Product / Process Change Notification (PCN)

PCN #: PCN_UtLAN_20200910

Affected Series: UtLAN;

APPLY EPOXY
4 PLACES

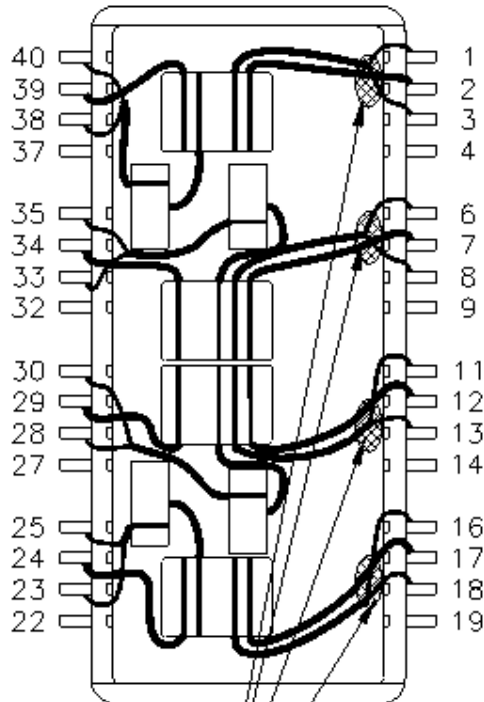
There will be change of epoxy used in securing toroids to headers and used in securing wires to toroids from Hysol EE1068 + HD3942 to Eccobond G500HF. The location of the epoxy change is shown on the next page. Please be aware location may differ slightly for each different part. This change is due to supplier obsolescence. Please see the reliability testing that was completed for this change on the next page.
